**ICC 500-2020 edition
Public Input Agenda with
Committee Votes and Public Comments
based on input received
on 2014 edition of the
ICC 500 Standard**

**For February, 2020
2nd Meeting – Teleconference**

2014 ICC 500-Standard Revision Proposals – Public Comments

Figure 504.1.1

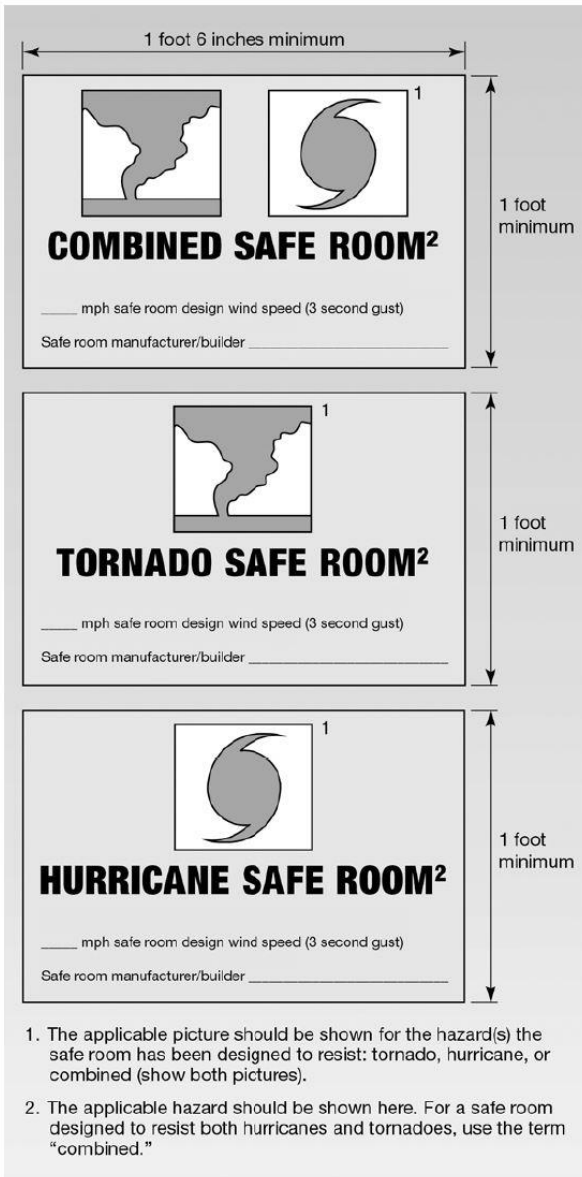
Staff Note: Modifications were also submitted for Commentary Figure 504.1.1 and 504.1.2

Add “Tornado Shelter Design Capacity: 1,500” to Figure 504.1.1.

Add “Tornado Shelter Design Capacity: 2,500” and “Hurricane Shelter Design Capacity: 1,500: to the top sign in Figure 504.1.2.

Add “Tornado Shelter Design Capacity: 400” to the middle sign in Figure 504.1.2.

Add “Hurricane Shelter Design Capacity: 2,000” to the bottom sign in Figure 504.1.2.

Committee Action: As modified (7-0 meeting) (12-0 electronic vote)

FIGURE ~~303.2~~ 303.1.1

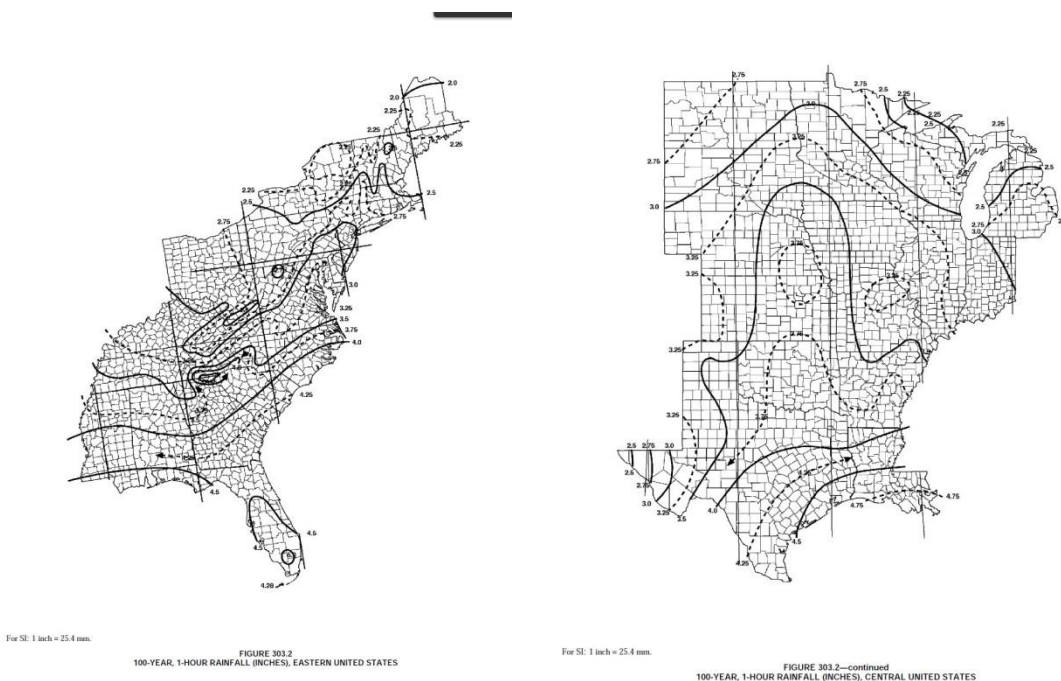
Reason: Figure 303.2 is referenced in Section 303.1.1 and not in Section 303.2. Section 303.2 has nothing to do with the figure.

303.1.1. Rainfall rate. The rainfall rate shall be determined by adding 6 inches (152.4 mm) of rainfall per hour to the rainfall rate established from Figure ~~303.2~~ 303.1.1.

FIGURE 303.2 303.1.1

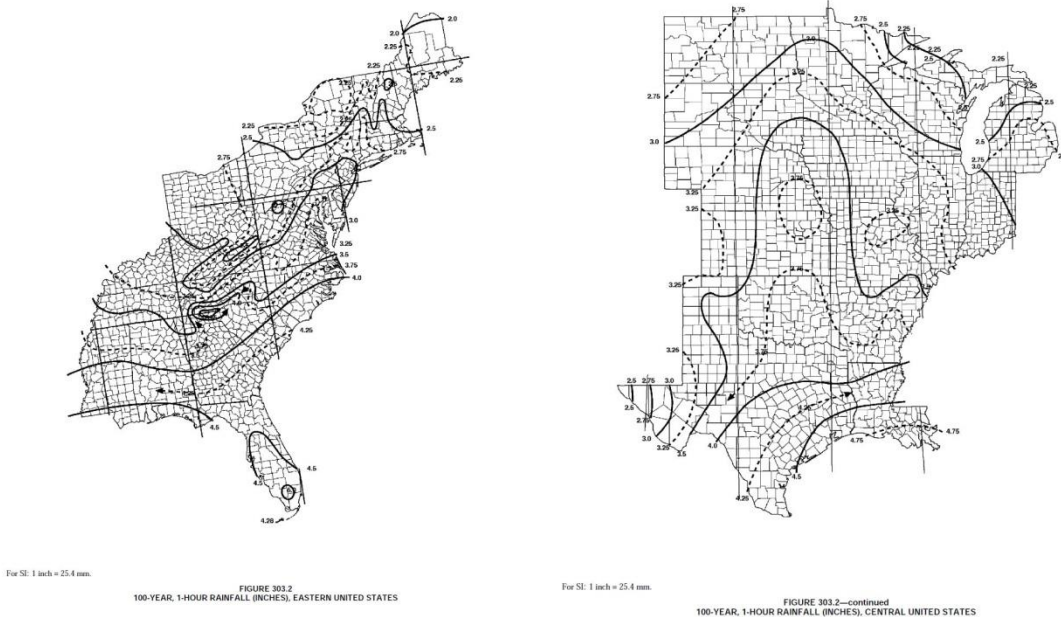
Committee action: Approval as Further Modified		
	Affirmative	Affirmative with comment	Negative with comment	Abstain with reason
Schultz Vote:		x		
Your comment/reason: 303.1.1 Rainfall rate states “or from approved local weather data”. It is unclear who is the approver of this data?				
No revisions suggested.				
<p>303.1.1. Rainfall rate. The rainfall rate shall be determined by adding 6 inches (152.4 mm) of rainfall per hour to the 100-year, 1-hour rainfall rate. The 100-year, 1 hour rainfall rate shall be determined from Figure 303.1.1 or approved local weather data.</p>

Committee action: Approval as Further Modified		
	Affirmative	Affirmative with comment	Negative with comment	Abstain with reason
Scott Vote:		x		
Your comment/reason: Editorial – “Western” in Western United States map caption is spelled wrong (Westerm)				
Revise as follows:				
<p>FIGURE 303.1.1—continued 100-YEAR, 1-HOUR RAINFALL (INCHES), WESTERN WESTERM UNITED STATES</p>

303.1.1. Rainfall rate. The rainfall rate shall be determined by adding 6 inches (152.4 mm) of rainfall per hour to the 100-year, 1-hour rainfall rate established from Figure ~~303.2~~ 303.1.1. For locations not illustrated in the figure, determine the 100 year, 1-hour rainfall rate from approved local weather data.

Figure 304.2(2) SHELTER DESIGN WIND SPEEDS FOR HURRICANES

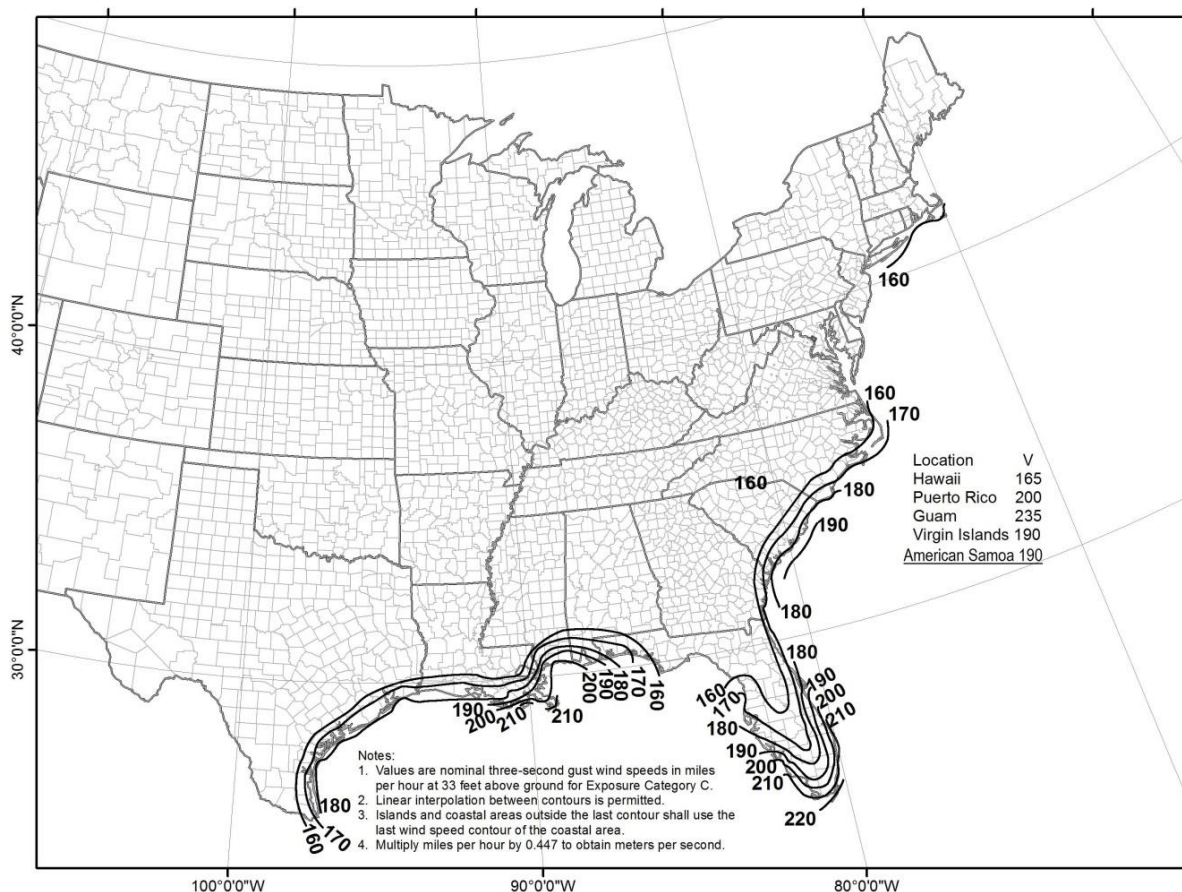
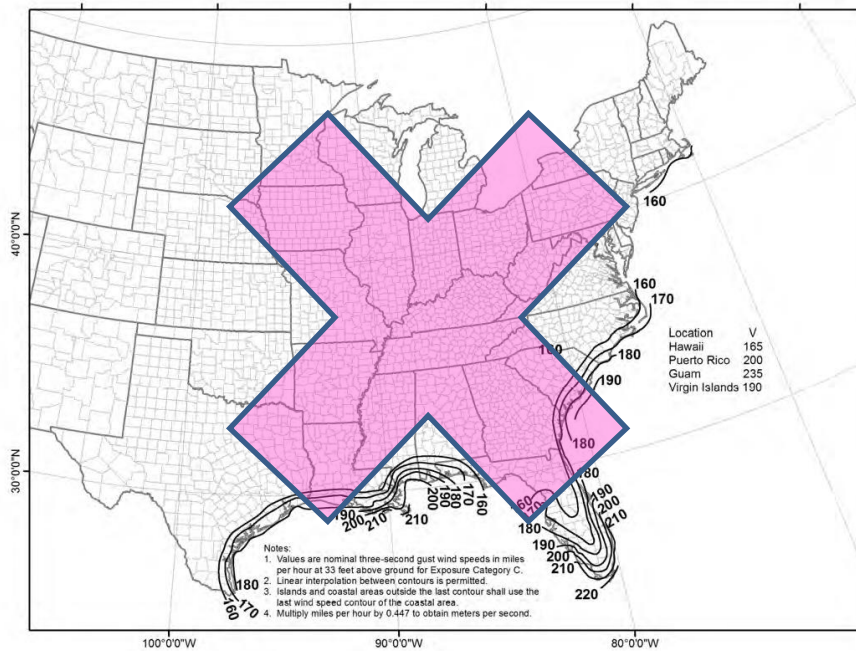
Reason: Currently Figure 304.2(2), the Shelter Design Wind Speeds for Hurricanes, does not specify a design wind speed for American Samoa where hurricanes are the greatest high wind hazard, and a 10,000 year MRI analysis is not currently available. From the ASCE 7 wind speed maps for 300, 700, 1700, and 3000 years, it turns out that the Virgin Islands and American Samoa wind speeds at each of these return periods are almost identical, meaning the hazard curves have a similar shape at the two locations. On the ASCE 7-16 Risk Category IV map,

American Samoa and the US Virgin Islands both have design wind speed of 180 mph. Therefore, the proposed wind speed for American Samoa is the same as the 10,000 year MRI wind speed that is currently used for the US Virgin Islands, 190 mph.

Committee Action: Approved as Modified (10-0)

Notes: Will also revise name for US Virgin Islands and add Commonwealth of the Northern Mariana Islands and American Samoa to full map. ARA will provide revised map for standard.

Rotate maps to landscape in final draft.

FIGURE 304.2(2)
STORM SHELTER DESIGN WIND SPEEDS, V , FOR HURRICANES

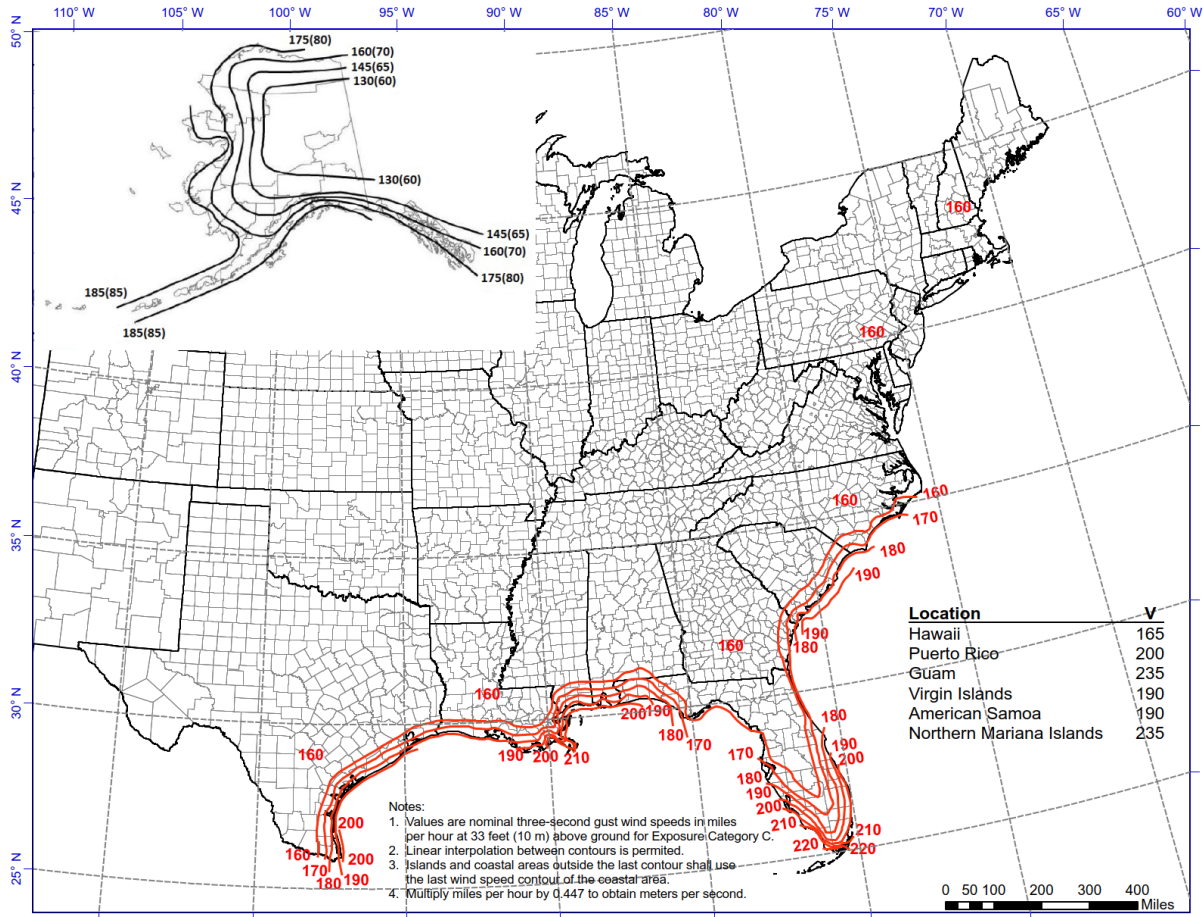
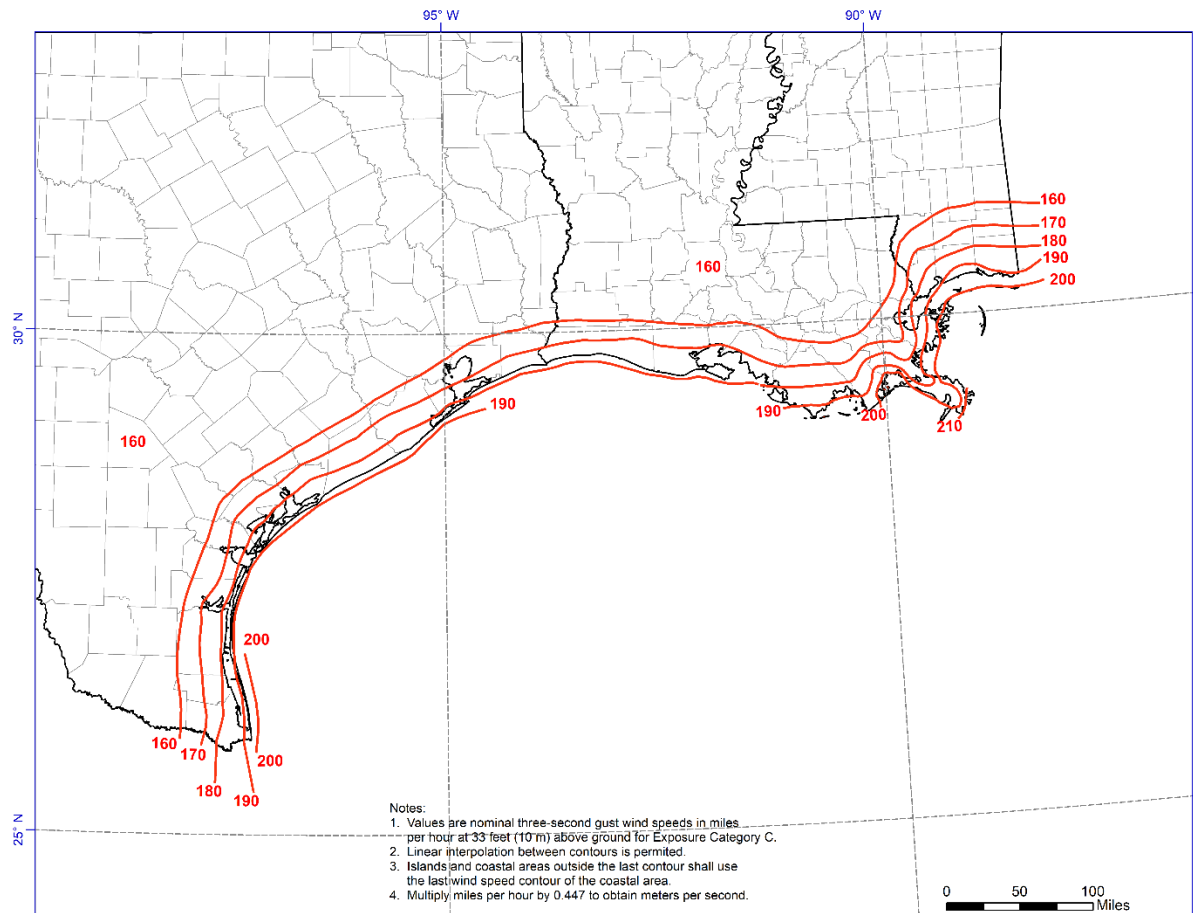
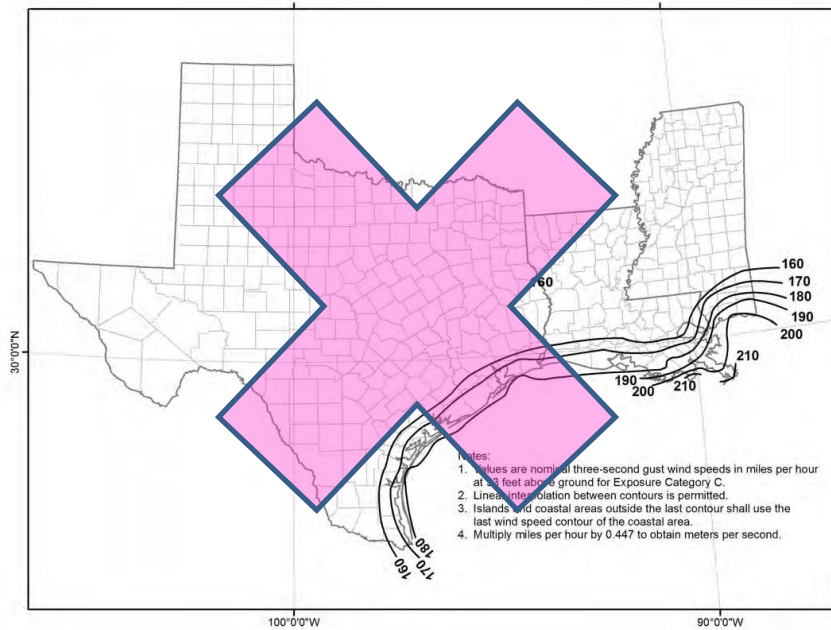
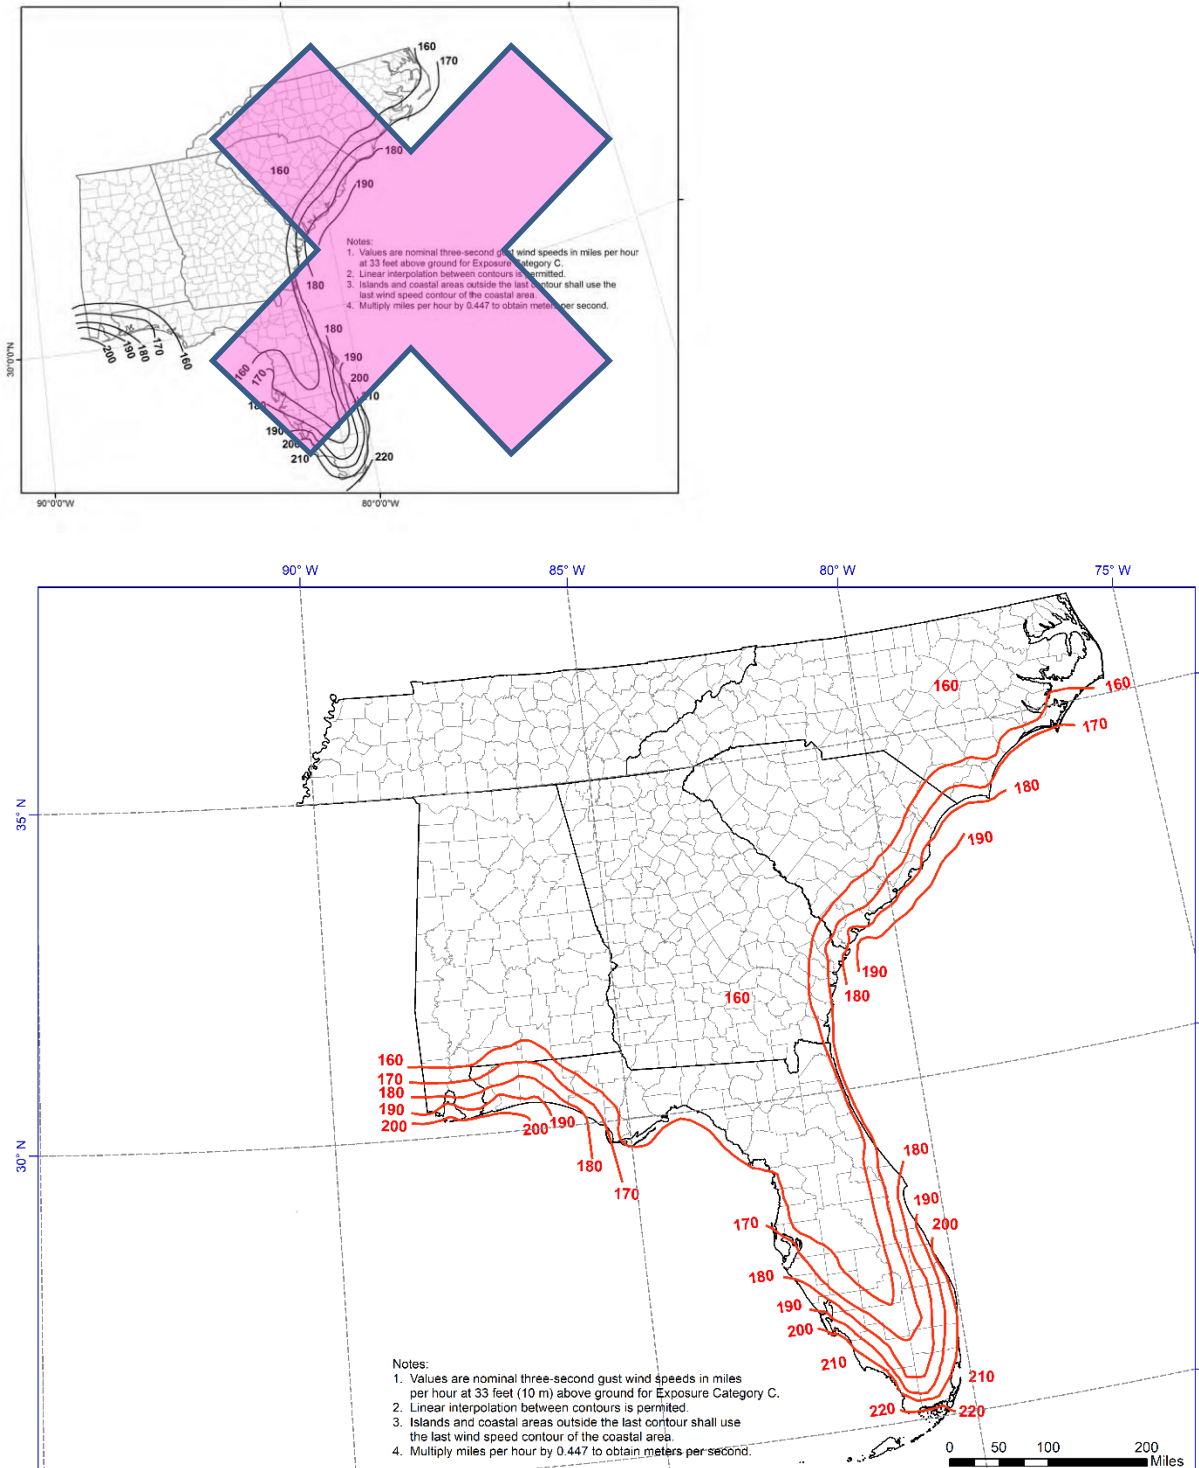
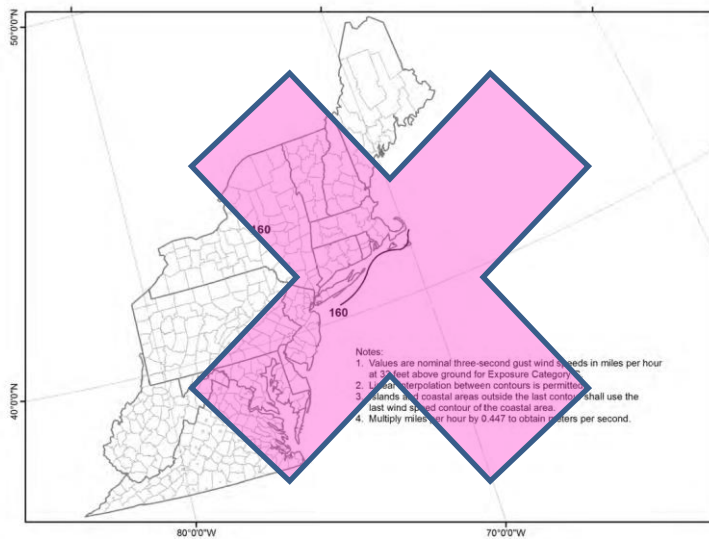
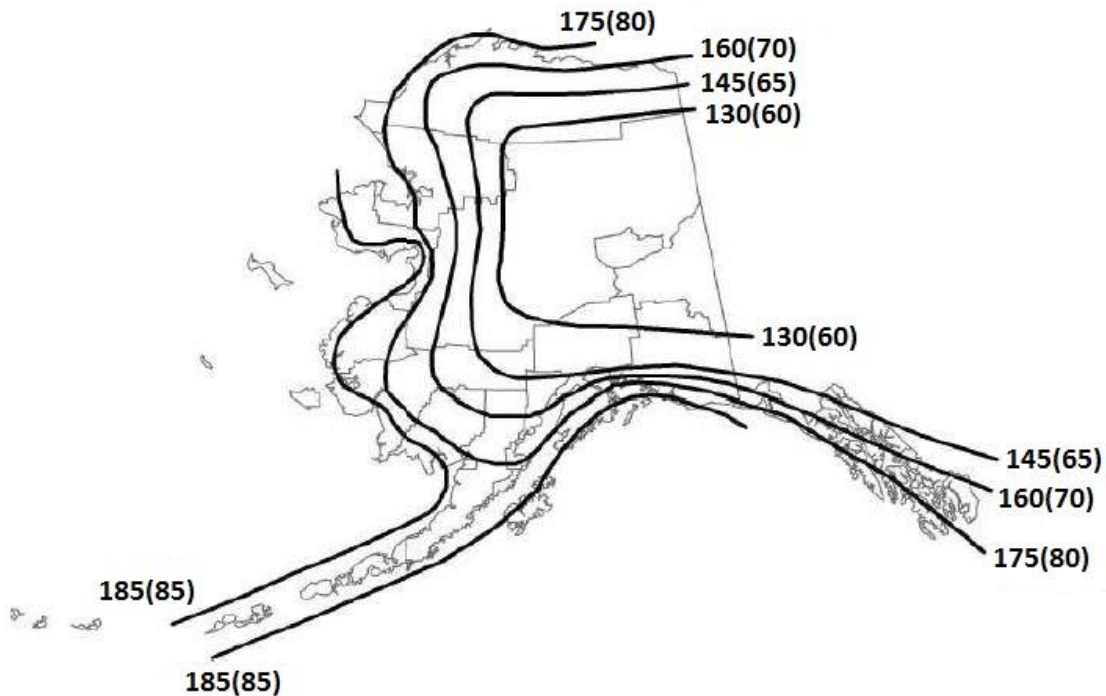
Committee Reason: Revised maps to coordinate with latest information for hurricane winds. Add Alaska because that state is affected by hurricane winds. Full list of islands is needed.

Delete four current maps and replace with the following
